UNITED STATES PATENT AND TRADEMARK OFFICE

Office Action Summary

10/534,690

DETAILED ACTION

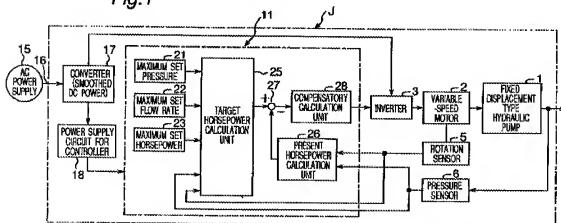
6. In Re claims 3 and 8, a dependant claim has all the limitations of the independent claim on which it depends, in this case claims 1 and 6. However, "changing the command value in correspondence with a detection value of the power source voltage" in claim 3 is broader than "increasing the command value in correspondence with an increasing amount of a detected power source voltage" in claim 1. Therefore for example a method step of decreasing a command value with increase in detected power source voltage would read on claim 3 (changing command value with detection) however, it would contradict claim 1 which increases command value with increasing detected power source voltage". Same reasoning applies to claim 8 (depends on 6).

Fig. 1

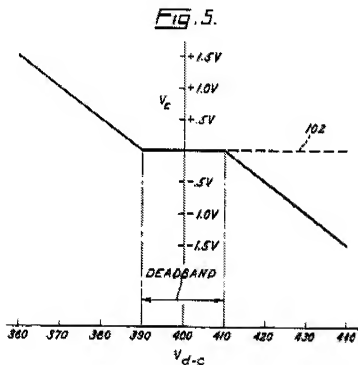
10. In Re claims 1 and 6, with reference to Figure 1 depicted above, Horiuchi et al discloses a pump driving method comprising:

- driving a motor (2) using a controller (11) which executes commands (values)
- carrying out feedback control of the discharge pressure using the signal from the pressure sensor (6) (as described in line 3, Page 4, Paragraph [0021])
- driving a pump (1) using motor (2) (as described in line 14, Page 4, Paragraph [0021])

- an apparatus (11), (21), (22), (23), (25), (27), (28) that is capable of making changes to the control algorithm if necessary

11. However, Horiuchi et al does not disclose increasing the command value in correspondence with an increasing amount of a detected power source voltage.
